ADDENDUM NO. 2

DATE: February 24, 2023

RE: Dickinson Park Sports Fields Renovations
Project No.: 21-1558

Drawings: (all revisions have been clouded and tagged with a delta-2)

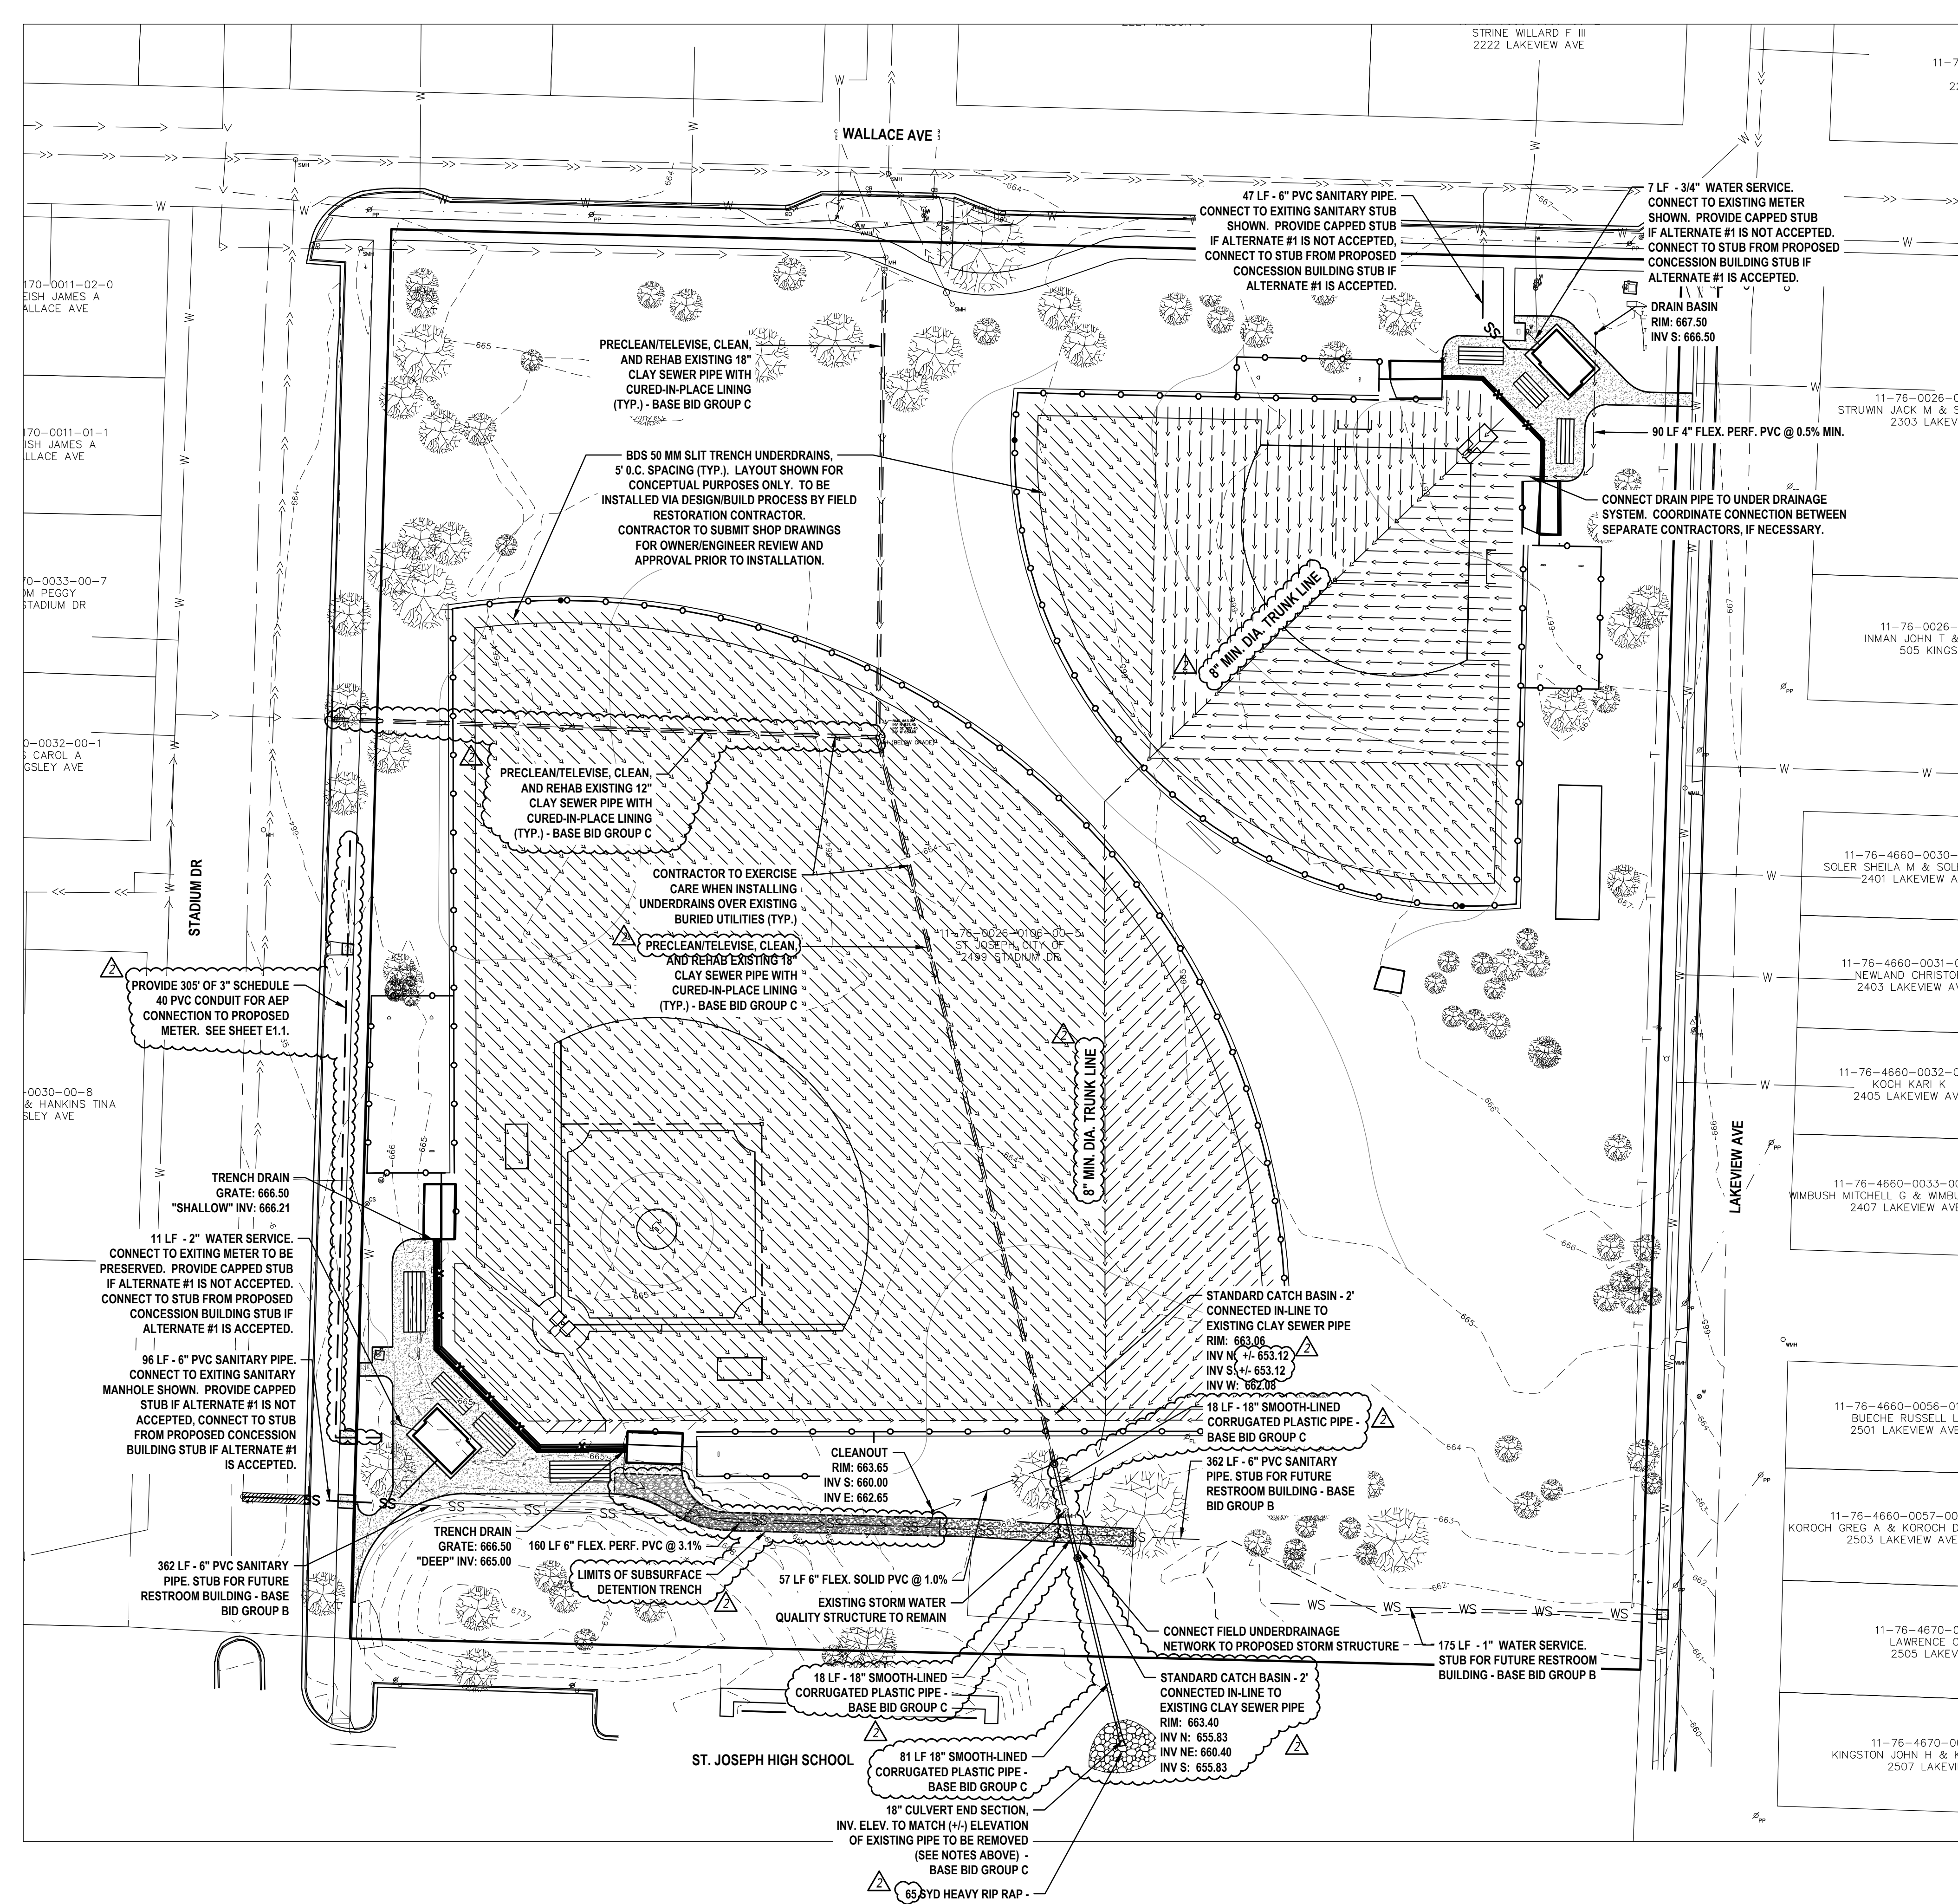
- a. Revise 18" clay sewer pipe note.
 - b. Add note - preclean/televise, clean, and rehab existing 12" clay sewer pipe with cured-in-place lining.
 - c. Add outline noting limits of subsurface detention trench.

- d. Revise proposed invert elevations for standard catch basin – 2'.
 - e. Revise material for all proposed storm sewer pipes south of the proposed standard catch basin.

- f. Add standard catch basin – 2' south of the existing storm water quality unit north of the baseball field batting cages.
 - g. Revise quantity of Heavy Rip Rap

NOTES
 1. ONLY INFORMATION DIFFERING FROM BASE BID UTILITY PLAN (SHEET 10) IS NOTED. ALL BASE BID SCOPE ITEMS, NOTES, ETC. REMAIN IN CONTRACT IF NOT SPECIFICALLY NOTED OTHERWISE ON THIS ALTERNATE 2 UTILITY PLAN.

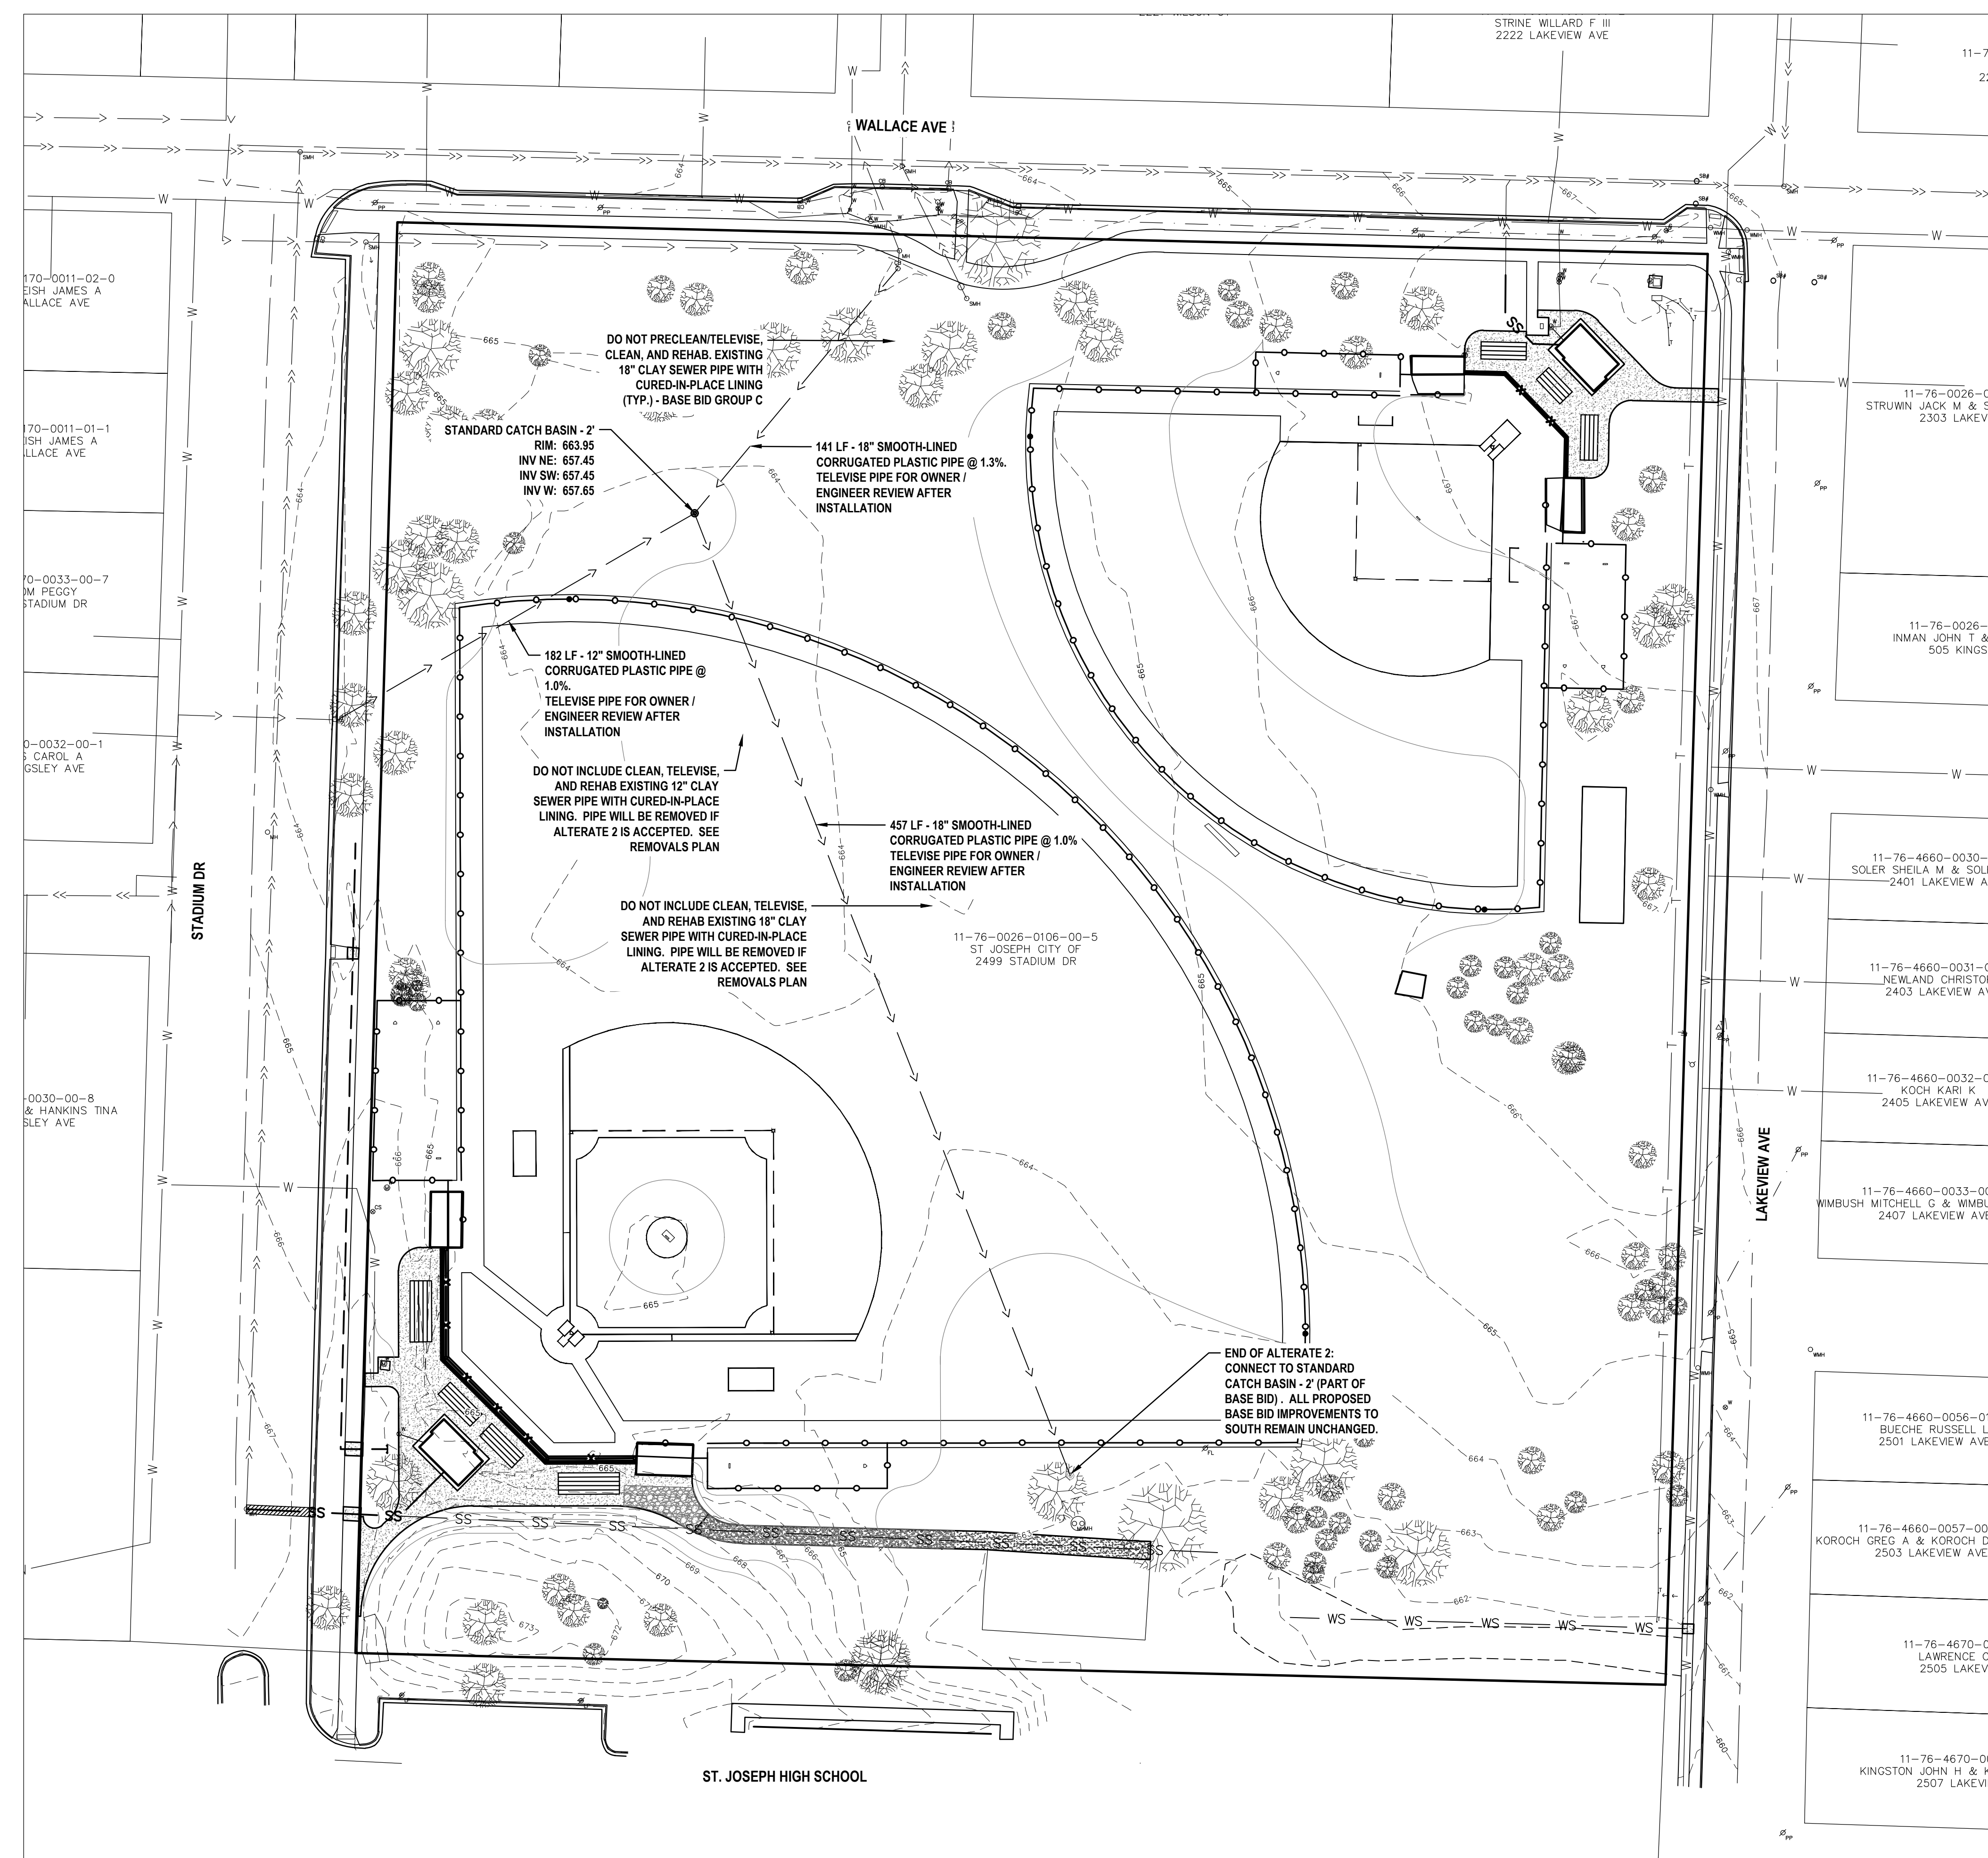
7. Sheet 11 – Alternate Utility Plan
- a. Add sheet to set.
8. Sheet 12 – Landscape Plan
- a. Add restoration turf seeding within public ROW along Stadium Dr.

STANDARD CATCH BASIN - 2'
NOT TO SCALE

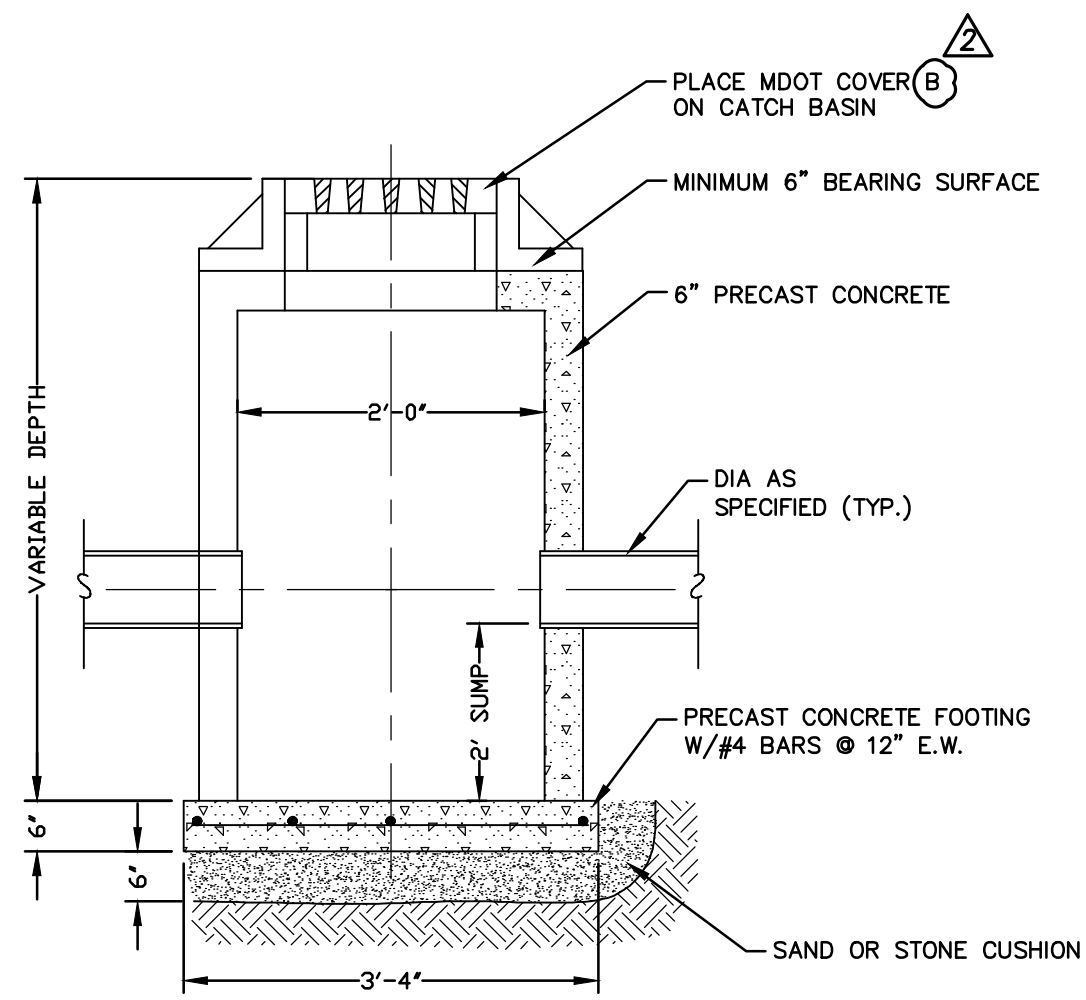
- b. Revise Bid Group C restoration turf seeding limits.
9. Sheet 14 – Construction Details
- a. Revise Standard Catch Basin – 2' cover to MDOT Cover B.
